Errata Sheet

Product Family:	DL405	Date:	September 2018
Manual Number	D4-DCM-M		
Revision and Date	1st Edition, Rev. A; June 1998

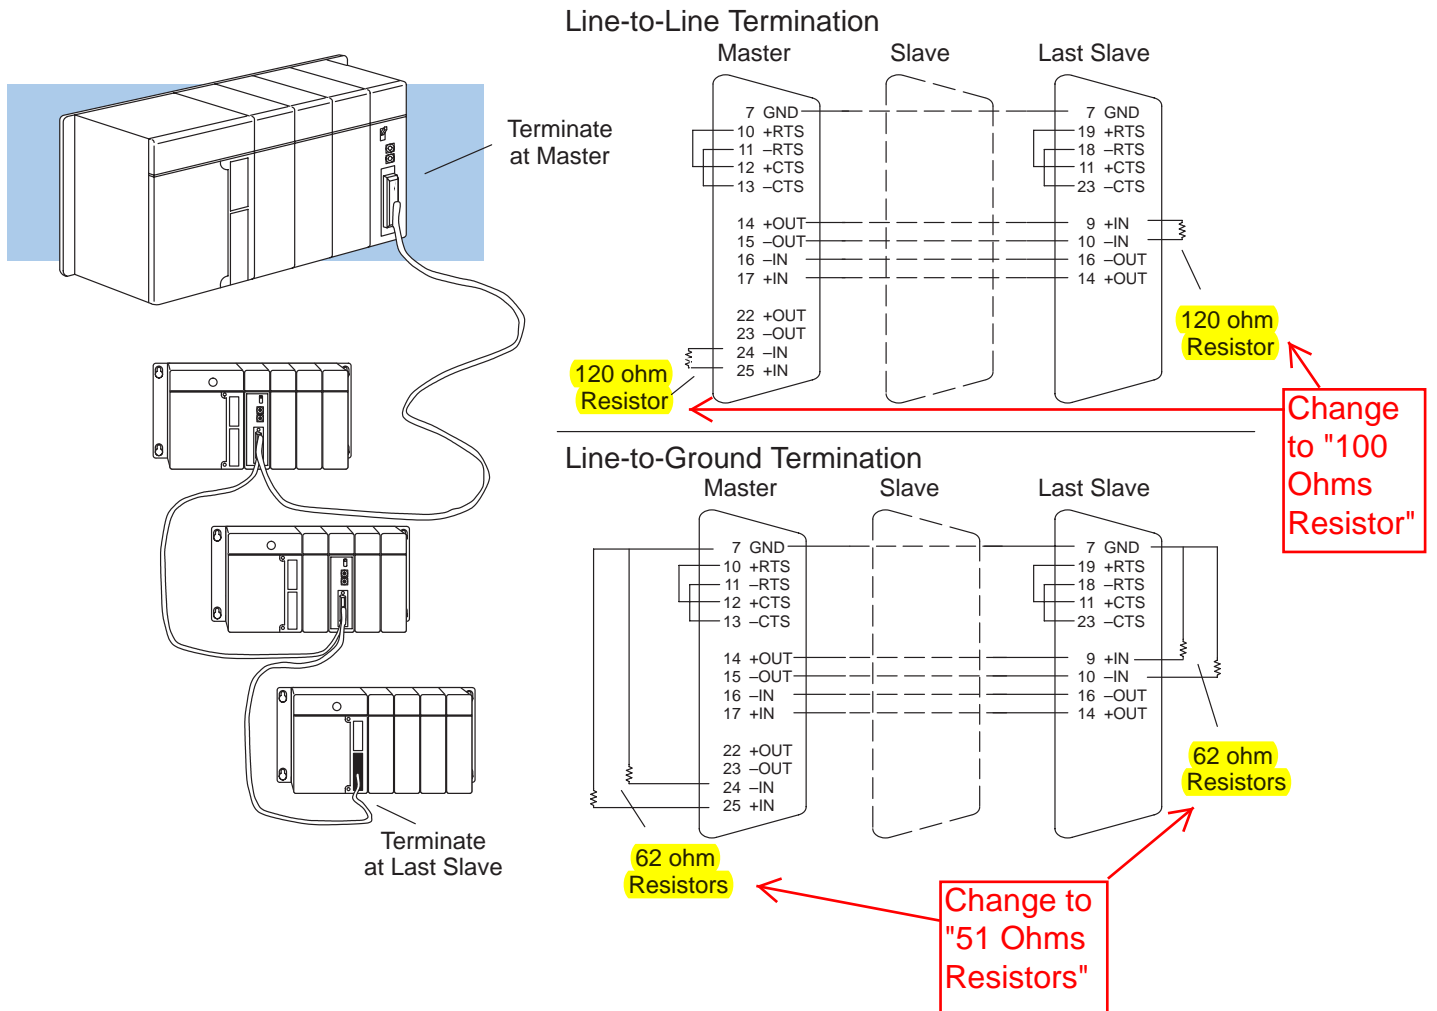
Also on page 17, change two callouts in the upper Line-to-Line Termination drawing. Change the callouts saying “120 ohm Resistor” to “100 Ohms Resistor”

Change two callouts in the lower Line-to-Ground Termination drawing. Change the callouts saying “62 ohm Resistors” to “51 Ohms Resistors”

Replace with: "For example, AutomationDirect L19772-1 (Belden 8102) or equivalent has a nominal characteristic impedance of 100 Ohms."
